ADDENDUM NO: 2

PROJECT: Pendleton Heights High School Roofing Replacement

PROJECT NO: 2024041

DATE: 07/29/2024

DRAWING TITLE:
ROOF
DEMOLITION
PLAN

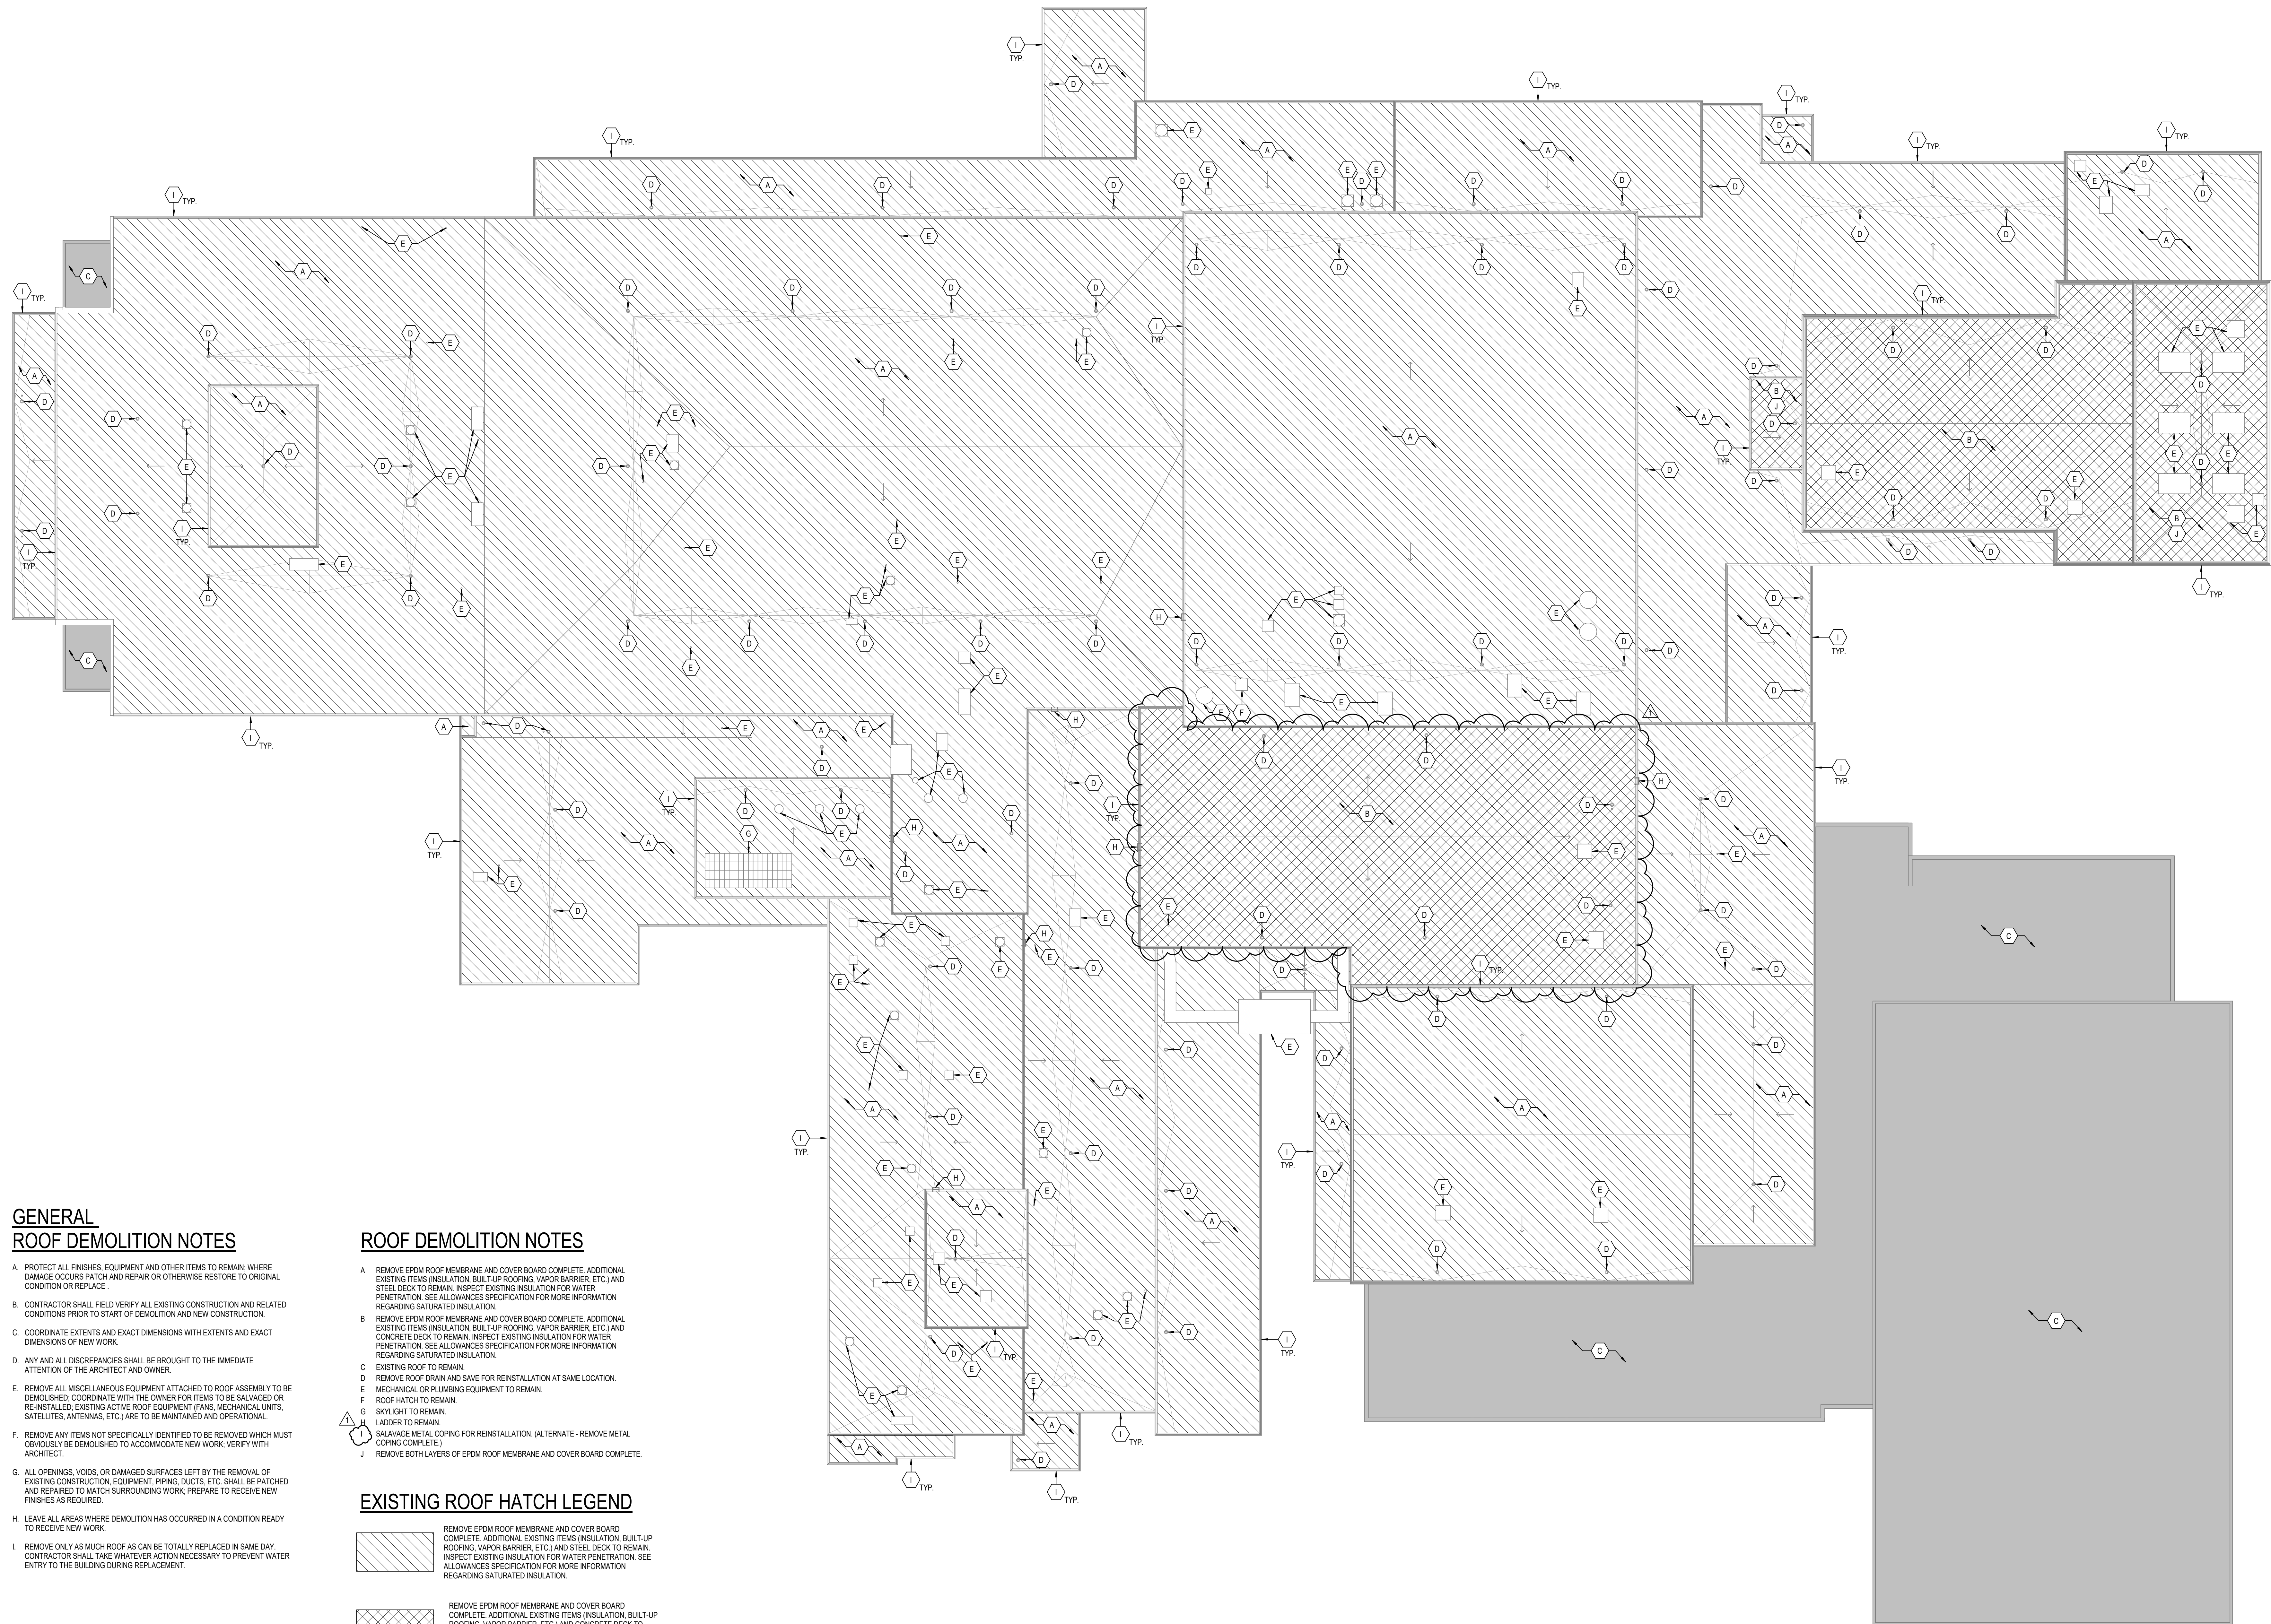
- A. Change roof demolition note and hatch as shown on the attached sheet to indicate additional area with concrete deck.
- B. Revise roof demolition note "I" to include alternate information.
